DEVIATION REQUEST AND DECISION FORM

| Project Name : Owl Marketplace Filing No. 1 |

A deviation from the standards of or in Section **2.4.1.E.4** of the Engineering Criteria Manual (ECM) is requested.

**OWL MARKETPLACE
TURNING MOVEMENTS
WB-62**

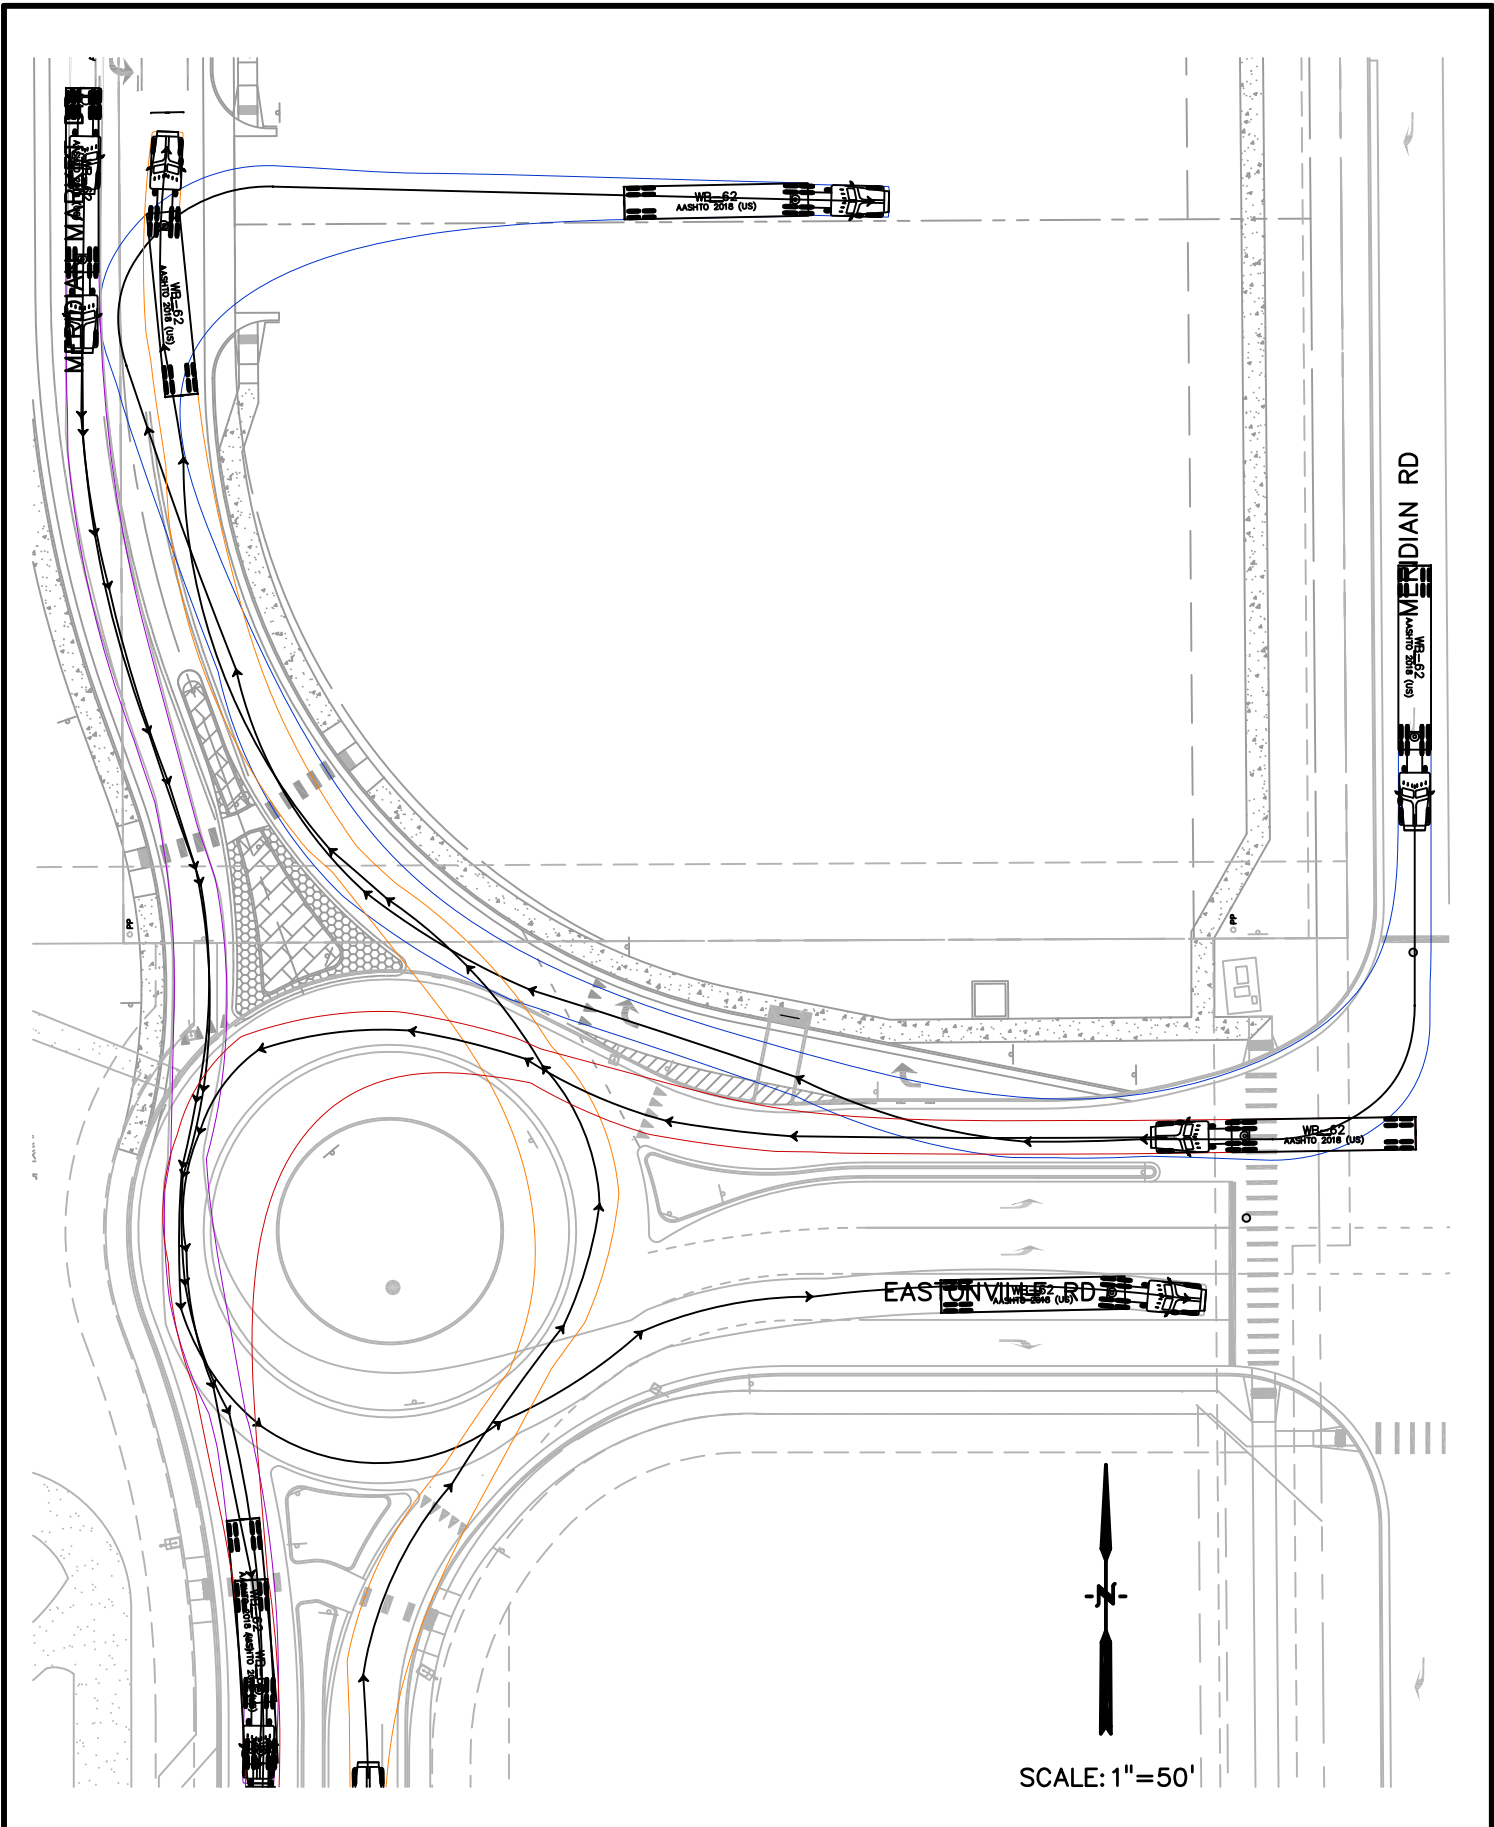
-2.4.1.E.4 Two-Way Commercial or Industrial Access Points – 40' wide. Proposed alternative 50' wide.

The proposed gas station use for Lot 1 Owl Marketplace (as indicated by the Site Development Plan application PPR244) will result in larger commercial gas tanker delivery trucks accessing the property. The access to Lot 1 is a shared driveway between Lots 1 and 2. The proposed use for Lot 2 is a fast-food restaurant. The larger (50') driveway width would allow for regular passenger vehicle traffic to maneuver through the intersection from both Lots 1 and 2, while allowing for truck traffic to safely access and turn through the proposed gas station on Lot 1. The attached truck turning movement for a WB-62 size vehicle indicates that approximately 9.5-ft spacing is available on the north side between the curb flowline and edge of truck turning movement, which indicates that a passenger vehicle would be able to safely sit at the intersection while a truck accesses the site.

The wider driveway will allow for the commercial truck traffic to access Lot 1 while allowing for regular passenger vehicles to utilize the intersection simultaneously. A narrower driveway would result in a truck turning movement impacting the west-facing traffic exiting Lots 1 or 2.

The widening of this driveway will result in the ability for two-way traffic to utilize the intersection, even when delivery trucks are present. Public safety will not be compromised at this intersection.

This request has been determined to have met the criteria for approval. A deviation from Section 2.4.1.E.4 of the ECM is hereby granted based on the justification provided.
